No: 000295

U  
S  
TSubject: CHANGE OF CANOPY AFT  
HINGE ATTACHMENT IN  
EAGLE II AIRCRAFT 904 AND  
915 CONSTRUCTION KITS

ENGINEERING SKETCH X-90136

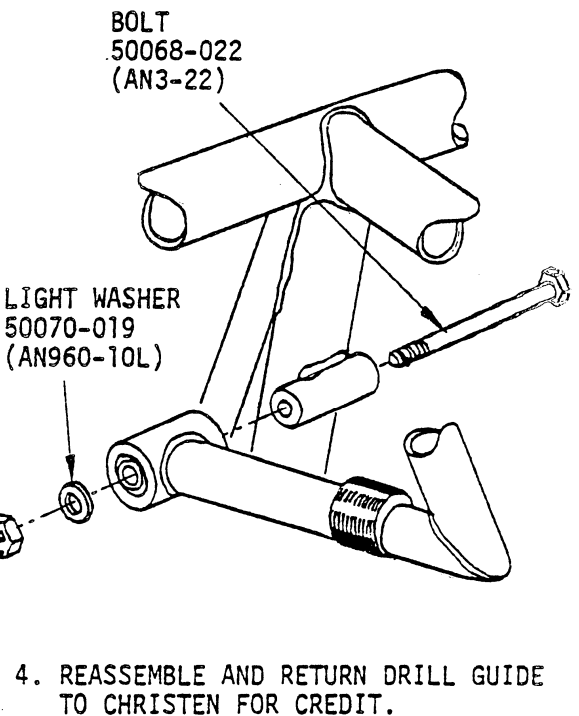
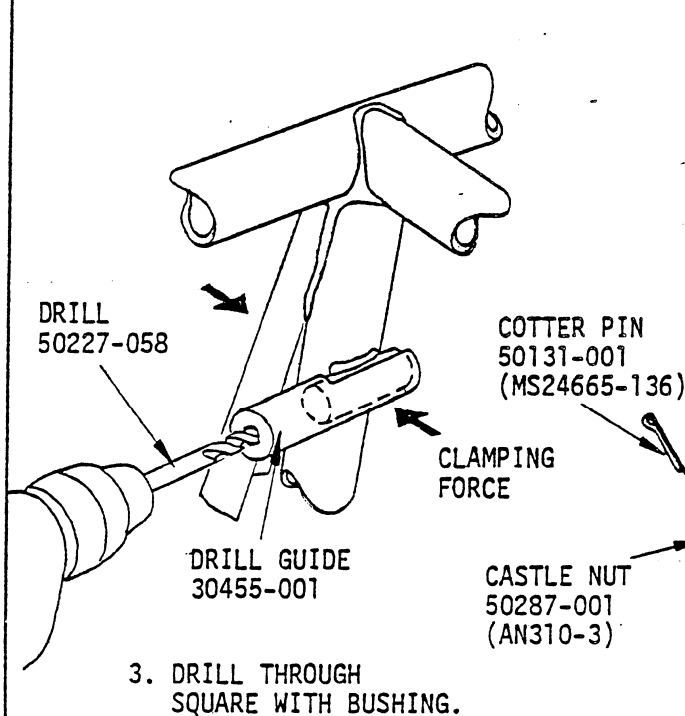
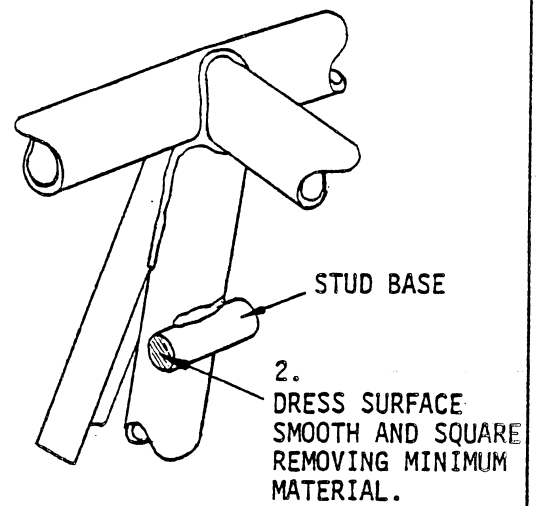
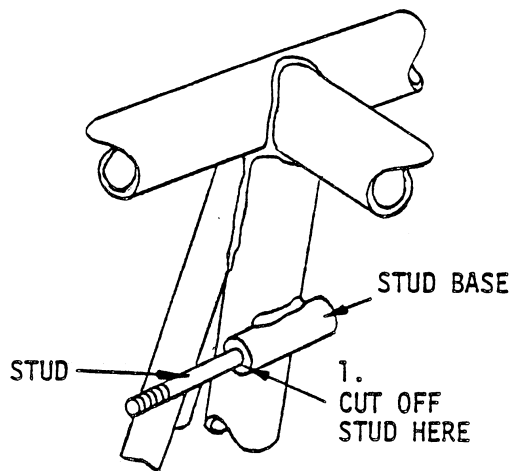
The fuselage modification procedure for the new hinge attachment consists of trimming off the original stud and drilling through the stud base to form a support bushing through which a new hinge support bolt can be mounted. A special drill guide and drill are required as listed below. (It is essential that a properly sharpened drill be used to ensure hole straightness, location, and angle.)

Modification of the canopy system consists of simply adding a bolt, castle nut and cotter pin to replace the original thin nut and support stud.

8. Secure the castle nut in its adjusted position with the 50131-001 cotter pin. Clinch the prongs of the cotter pin if the aircraft has been completed (through 923 Kit), or spread the prongs only slightly to keep the pin in position, but to allow removal later during remaining construction.
9. Reinstall all rear seat and canopy components as appropriate.
